STAFF REVIEW AND RECOMMENDATIONS
PUBLIC HEARING
OCTOBER 7, 2020

PRELIMINARY PLAT: SCOTWOOD ESTATES DIVISION VI PHASE 3
LEGAL DESCRIPTION: SEC 27, T18N, R01W, SEWARD MERIDIAN AK
PETITIONERS: SCOTT W. & KAYE M. HESSINGER
SURVEYOR/ENGINEER: KEYSTONE SURVEYING/
WALDEN CONSTRUCTION CONSULTING & ENGINEERING LLC
ACRES: 5.32 ± PARCELS: 3
REVIEWED BY: AMY OTTO-BUCHANAN CASE #: 2020-127

REQUEST: The request is to create three lots from Lot 11, Block 1, Scotwood Estates Division VI, Phase 2, Plat No. 2004-111, to be known as **SCOTWOOD ESTATES DIVISION VI, PHASE 3**, containing 5.32 acres +/- . The plat is located north and east of E. Schrock Road, and directly north of E. Barra Loop; within the NW ¼ Section 27, Township 18 North, Range 01 West, Seward Meridian, Alaska.

SCOTWOOD ESTATES DIVISION VI, PHASE 3
 A SUBDIVISION OF LOT 11
 SCOTWOOD ESTATES DIVISION VI, PHASE 2
 WITHIN THE NORTH SECTION 27
 TOWNSHIP 18 NORTH, RANGE 01 WEST
 SEWARD MERIDIAN, ALASKA
 PALMER RECORDING DISTRICT
 THIRD JUDICIAL DISTRICT
 STATE OF ALASKA
 CONTAINING 0.92 ACRES, MORE OR LESS

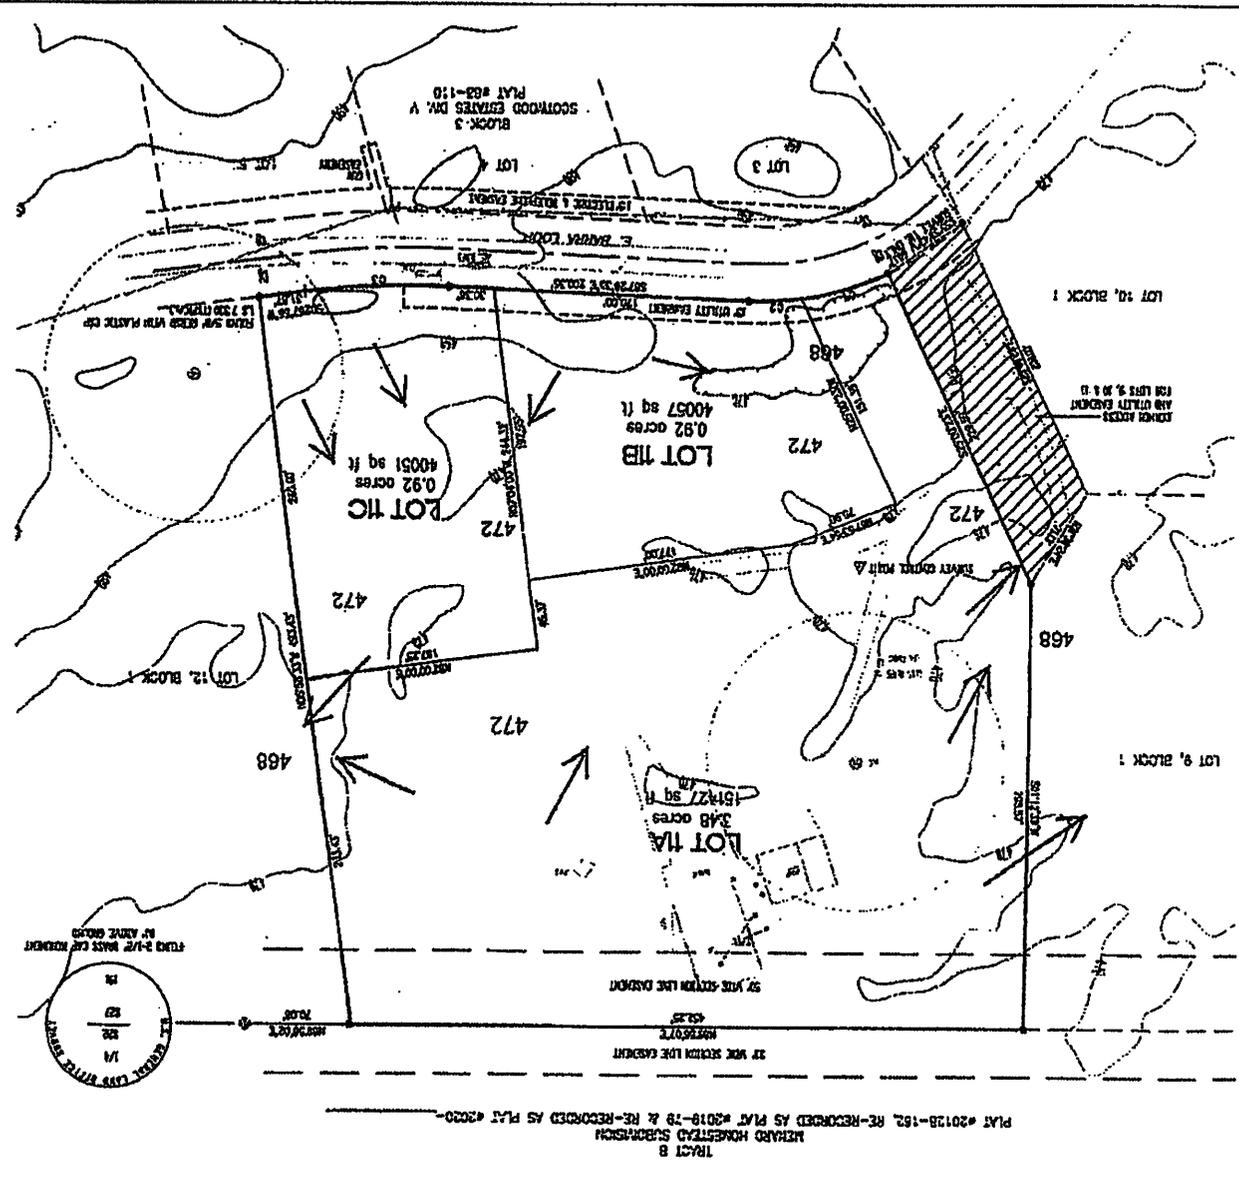
ENSTAR Natural Gas Company has reviewed **Scotwood Estates Division VI Phase 3 (MSB Case No: 2020-127)** and advises that there is an existing natural gas service line that appears to cross proposed Lot 11C to serve proposed Lot 11A. Attached is an approximate ENSTAR as-built for your reference. ENSTAR objects to the plat unless one of the following scenarios is met:

1. Add a note which says, "There is a ten foot (10 FT) wide natural gas easement centered on the existing service line." And draw in the approximate location of the service line on the map and add, "Approximate location of natural gas service line and centerline of ten foot (10 FT) wide natural gas easement".
2. Owner signs an ENSTAR Natural Gas Easement document for a ten foot (10 FT) wide natural gas easement, centered on the service line at this location.

Utilities: (**Exhibit E**) MTA has no comments. Enstar objects to the plat unless a notes is added which states there is a 10' wide natural gas easement centered on the existing services lines and the approximate location of the service line is added to the plat; or the owner signs an Enstar natural gas easement document for a 10' wide natural gas easement, centered on the service line at this location. *Staff notes an abbreviated plat does not grant easements. Petitioner may grant the easement by document and shown on final plat.* MEA and GCI did not respond.
